Amendments to the Drawings:

REMARKS

DYKEMA GOSSETT PLLC Third Floor West, Franklin Square 1300 I Street, N. W. Washington, DC 20005-3306 (202) 906-8600 ATTORNEY DOCKET NO.: 66291-160-2
Application No.: 08/973,305
Reply to Office Action of November 14, 2003
Annotated Sheet Show Changes

Annotated Sheet Show Changes

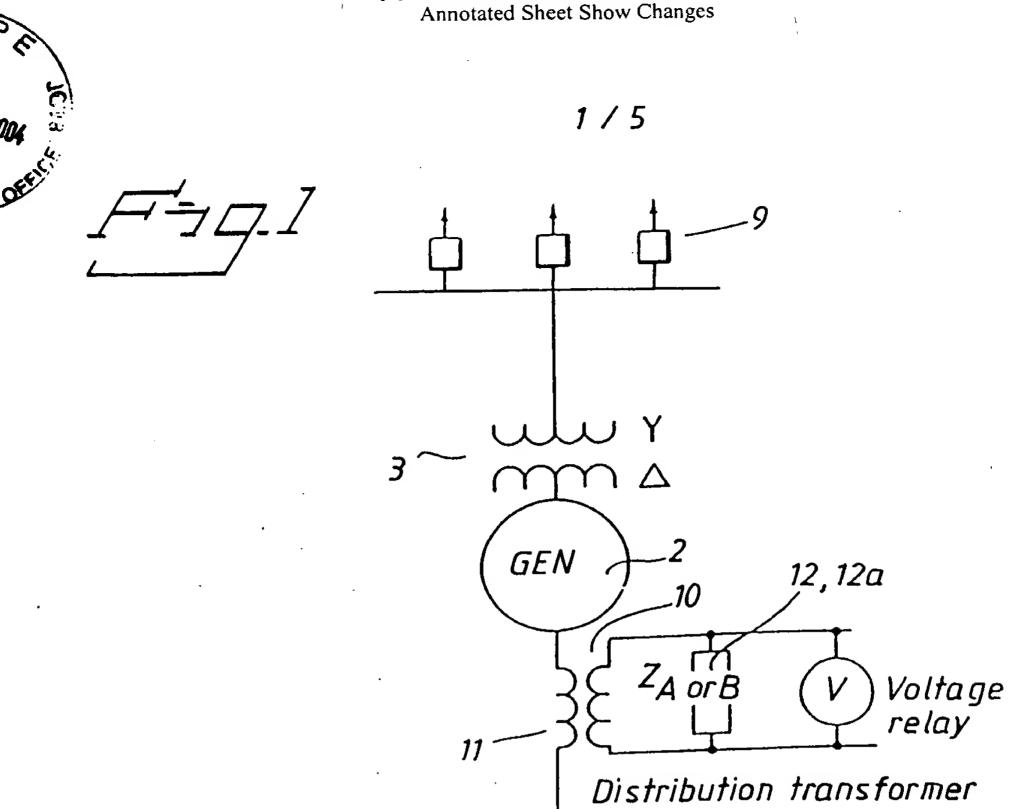
It is requested that the Examiner approve the amendment to Fig. 2, which adds a reference numeral 5A referring to the non-insulated strands. An Annotated Drawing is attached as well as the Replacement Sheet.

Figure 2 of the drawings has been amended in order to add a reference numeral 5A, which refers to the non-insulated strands. No new matter has been added.
